(MY1) FINAL MONITORING REPORT - *Stream Mitigation*

STRAWBERRY HILL MITIGATION PROJECT

Subject: DMS Comments on the MY1 Report
Strawberry Hill, Project ID #100094, DMS Contract 7745

RE: DMS Comments on the MY1 Report Strawberry Hill, Project ID #100094, DMS Contract 7745

Figure 2b - CCPV MY1 2022

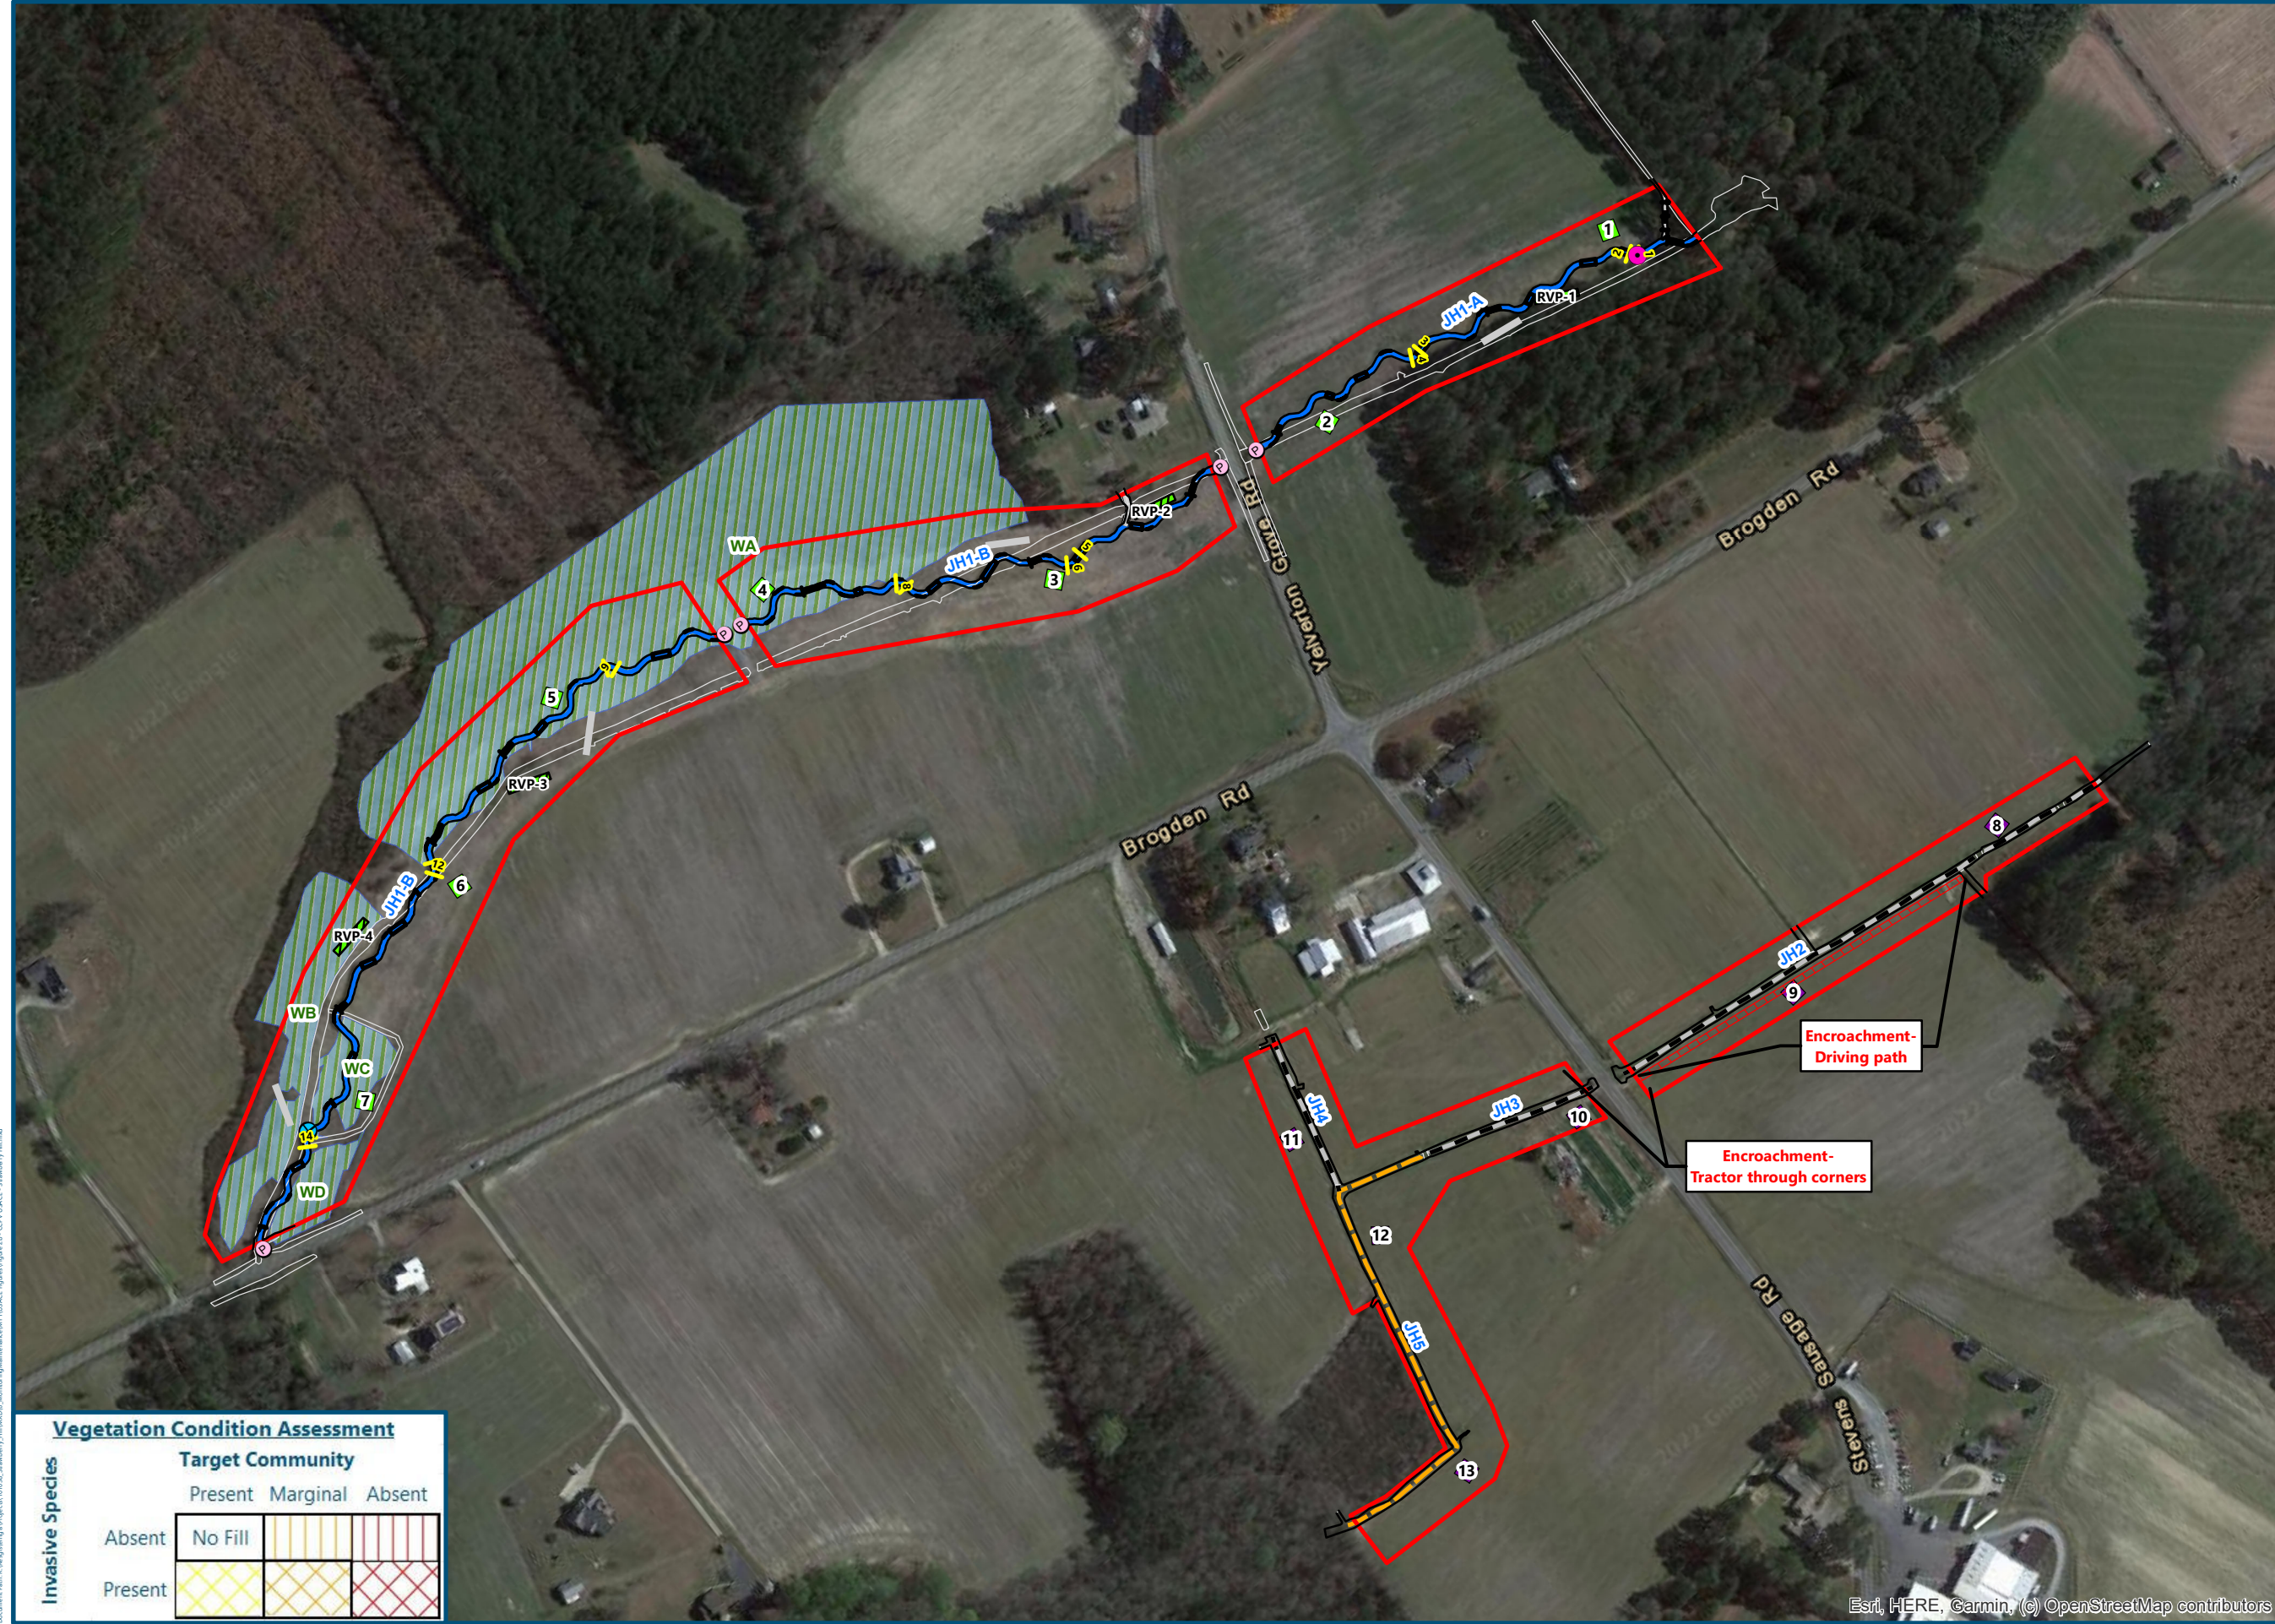
3. Recommend removing Figure 2b from the stream report.

[Figure 2b was included in the report in order to satisfy a previous DMS Digital File Comment from the MY0 report \(See excerpt below from the MYO Comment Response Memo\):](#)

[Figure 2 has been divided into Figure 2a and 2b so that monitoring devices are legible on 2a and the entire conservation easement is visible on 2b.](#)

Therefore, at this time, RES prefers to include the figure per the previous comment; however, if DMS concludes that the previous comment is erroneous, then RES can remove it in future years' monitoring reports.

2022 Flow Gauge JH1-A

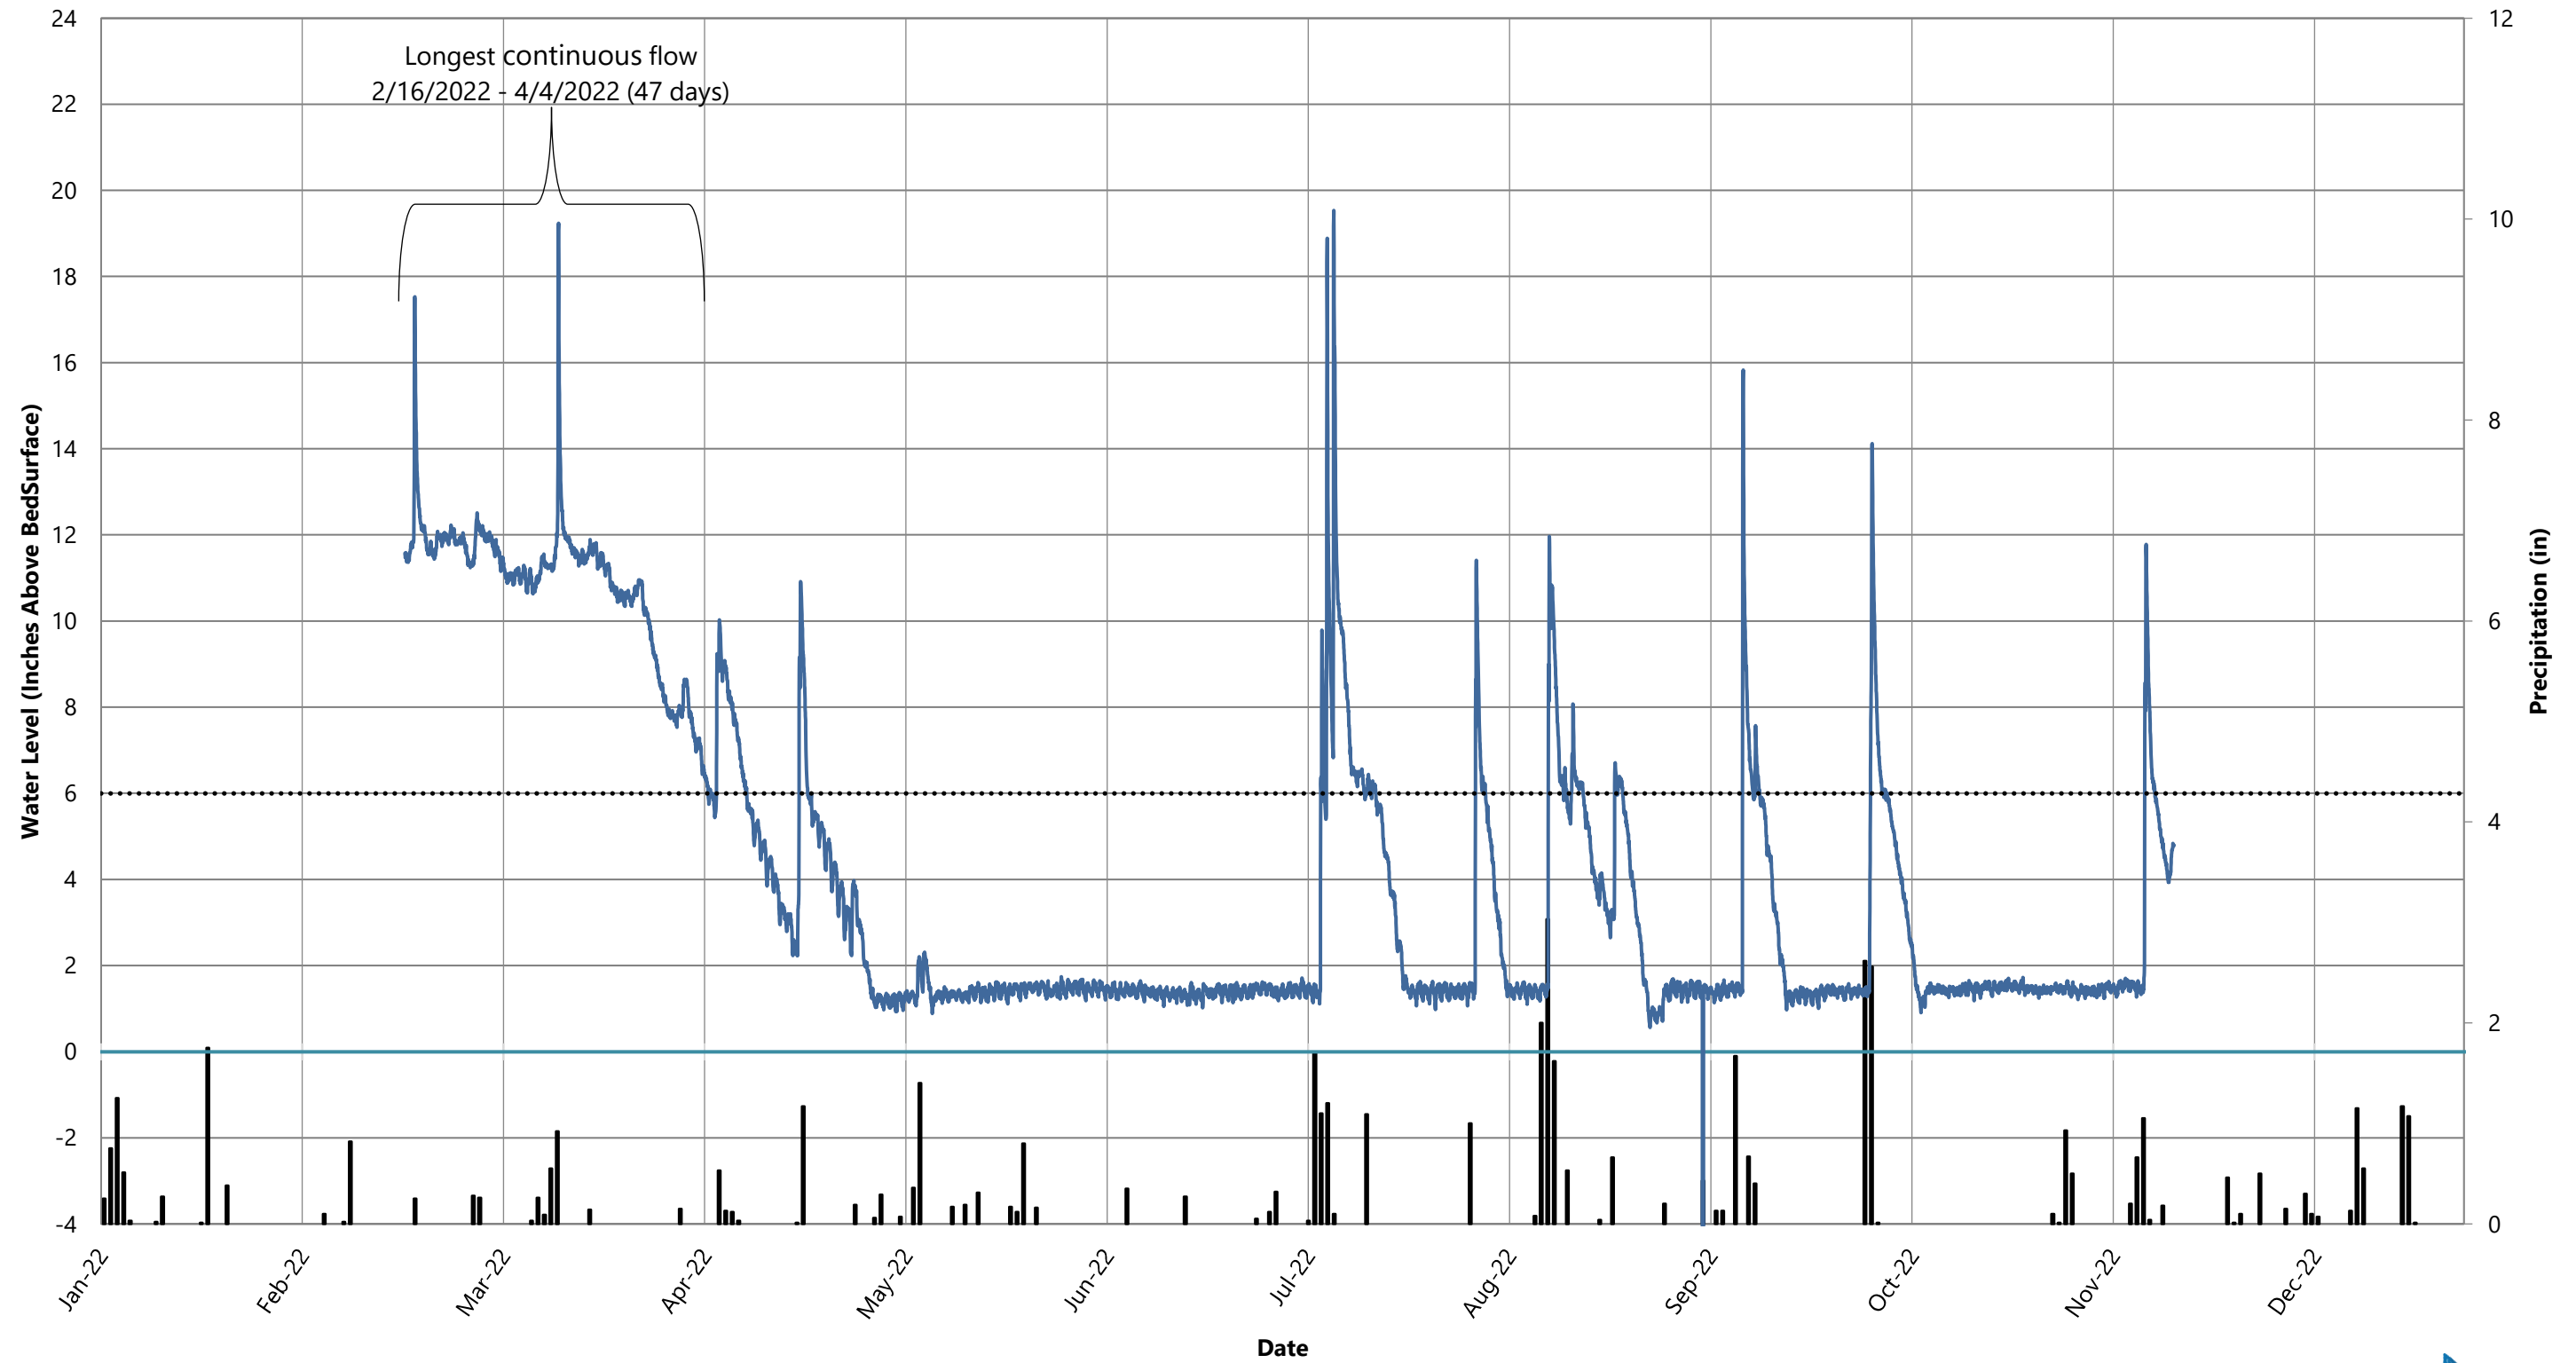
5. On Flow Gauge JH1-A hydrograph, recommend adding number of days of flow after the date range, i.e., 2/16/2022 - 4/4/2022 (47 days).

Number of days have been added to the hydrograph accordingly.
